1805 Larch St (COMPLETE APPLICATION)  
DP-2020-00385 – CD-1(748)

**DEVELOPMENT PERMIT STAFF COMMITTEE RECOMMENDATION: APPROVE**

**Figure1: An overlay of the rezoning building profile on the DP proposed elevation**

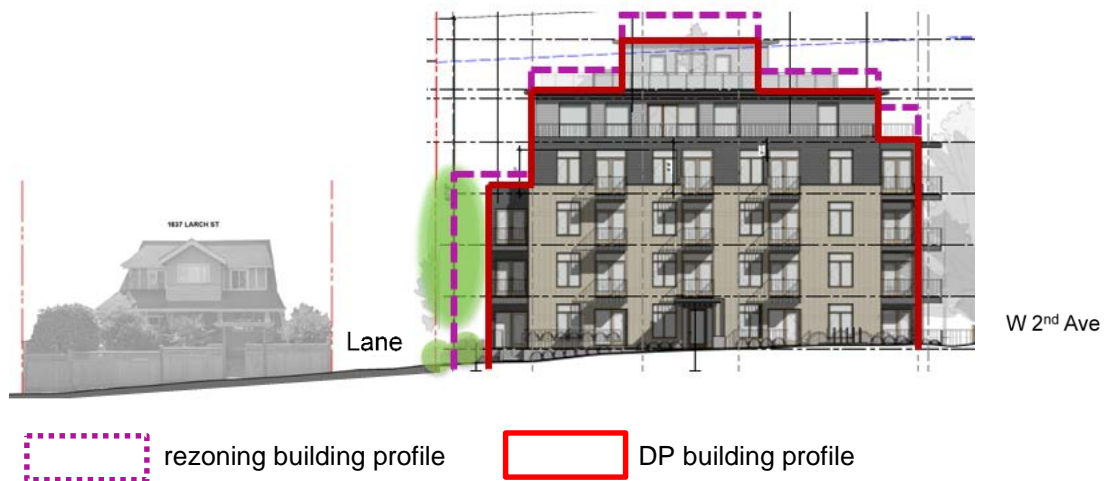
- Reduction of the overall building height by 3 ft (see figure 1);

- Increase of rear setback by ~7 f-t (from 3 ft to 10 ft) (see figure 1);
- Mitigation of perceived height and massing through articulation at the corner and edges of the volume, and emphasis of a 3-storey expression; (See figure 2)
- More compatible architectural characters, including a rhythm of entry porch, stair, and street access; incorporation of setbacks and projections on the wall plane; punched windows; and use of brick and lap siding; (See figure 2)
- Improvement of amenity spaces by co-locating an indoor amenity room with outdoor amenity space on the roof deck;
- Reduction of excessive parking; and
- Distribution of moderate income rental units throughout the building.

Figure 1 illustrates that the height and massing of DP application have been reduced from rezoning application to be more compatible with the surrounding low-rise buildings, and the setbacks from the lane has been increased to accommodate intense landscape buffer between the development and the existing neighboring houses across the lane.

- 1.1 design development to the rooftop amenity room to further reduce the perceived building height and massing through the following recommended design measures:
- i. reducing the area of rooftop amenity room, no more than 10% of the roof area on which it is located as viewed from directly above;
  - ii. limiting the dimensions of the amenity room no more than one third of the width of the building as measured on any elevation drawings; and
  - iii. locating the amenity room centrally with a minimum of 15 ft. setback from all edges of the roof and extra setback on the south side.
